**ZONING AMENDMENT
& SUBDIVISION STAFF REPORT****Date: November 3, 2016****APPLICANT NAME**

5955 Airport Subdivision

Subdivision approval to create 1 lot, and Zoning approval to rezone the site from R-1, Single Family Residential District and B-2, Neighborhood Business District, to B-2, Neighborhood Business District, to eliminate split zoning. It should be noted, however, that any use permitted in the proposed district would be allowed at this location if the zoning is changed. Furthermore, the Planning Commission may consider zoning classifications other than that sought by the applicant for this property.

PROPOSED SITE PLAN

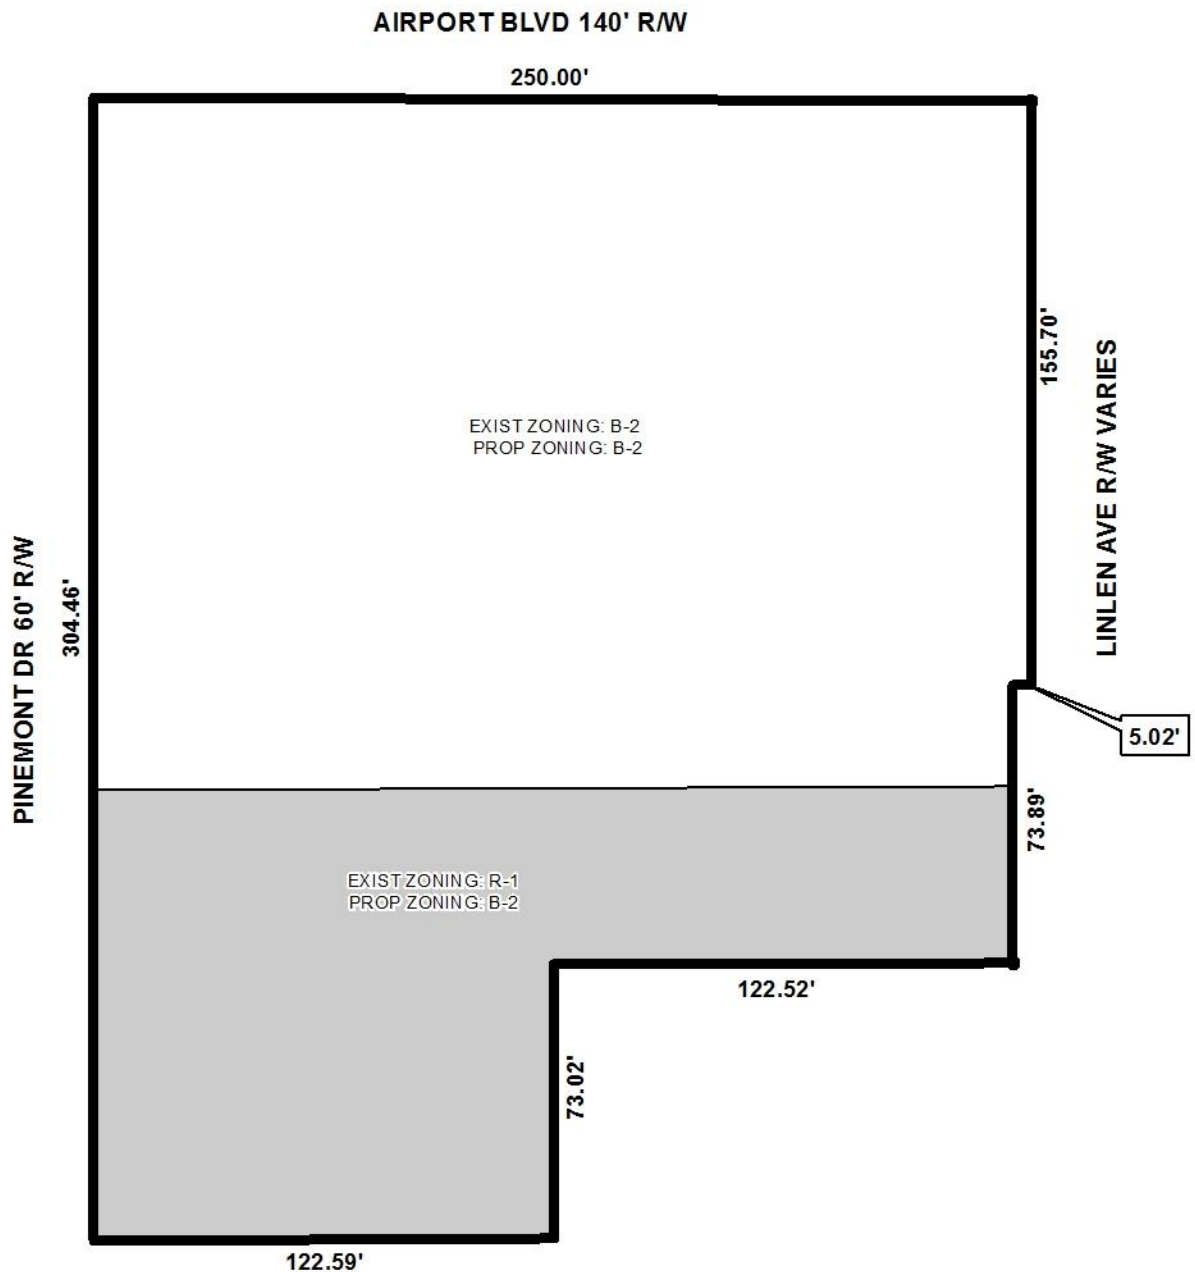
Furthermore, the subject site abuts residentially-zoned properties. Per Section 64-4.D.1 of the Zoning Ordinance, where a commercially utilized building site adjoins a residentially utilized building site, there shall be a protection buffer strip of not less than ten (10) feet in width. Any required yard shall be counted as part of such protection buffer strip. The protection buffer may be a wall, fence, or a screen planting strip that complies with the regulations for walls/fences, screen planting strips, and buffer strips within the Zoning Ordinance. It should be mentioned that a portion of the land buffer strip along the southern edge of the site appears to be less than 10' in width, and will need to be revised accordingly on the site plan. Also, the buffer strip does not clearly indicate if a fence, wall, or screen planting strip will be provided as a buffer, in conjunction with the land strip. If a fence or wall is to be provided, the fence type and height should be depicted on the revised site plan and ensure that setback requirements are met.

The existing building structure is approximately 13,137 square feet. At a parking ratio of 1/300, the existing structure and proposed use as a medical clinic will require 43 onsite parking spaces. Currently, the existing site has a total of approximately 60± parking spaces, with 40± parking spaces in the front and 20 parking spaces in the rear (according to the combined parking spaces depicted on both the preliminary plat and site plan). However, all existing and proposed parking spaces should be illustrated on the revised site plan and ensure that each parking stall measures 9' wide by 18' long. The boxed area in the front parking lot on the revised site plan should clearly indicate each parking stall, dimensioned appropriately. The applicant proposes to place 51 new parking spaces in the rear parking lot area. The redevelopment of the rear parking lot area will increase total onsite parking from 60± to 111± parking spaces; however, it should be mentioned that the existing parking spaces are over the number required for this site, and the applicant does not necessarily have to expand the rear parking area as 17 additional parking spaces are available. Also, because the parking is proposed to be expanded by more than 25%, a photometric site plan will be required at permitting.

In regards to the existing and proposed parking areas, the access drives and aisle widths appear to be compliant with the requirements of the Zoning Ordinance; however, the parking area must provide lighting in compliance with Section 64-6.A.3 of the Zoning Ordinance at time of permitting.

The site plan does not indicate the method of garbage collection for the subject site. The site plan should be revised to illustrate that onsite garbage collection will be served via a dumpster with a compliant enclosure with a connection to sanitary sewer in accordance with Section 64-4.D.9 of the Zoning Ordinance, or the placement of a note on the site plan indicating such. If a dumpster will not be provided, a note should be placed on the site plan stating that garbage collection will be provided via curbside or by private garbage collection services. Also, the revised site plan must ensure that the dumpster, if provided, is not within the 10-foot residential buffer.

The location and dimensions of the existing and/or proposed HVAC mechanical equipment for the proposed medical building structure is not illustrated on the site plan. The site plan should be revised to indicate the location, height and size of the HVAC mechanical equipment (i.e. HVAC units, generators, etc.) in compliance with Section 64-4.D.11 of the Zoning Ordinance.
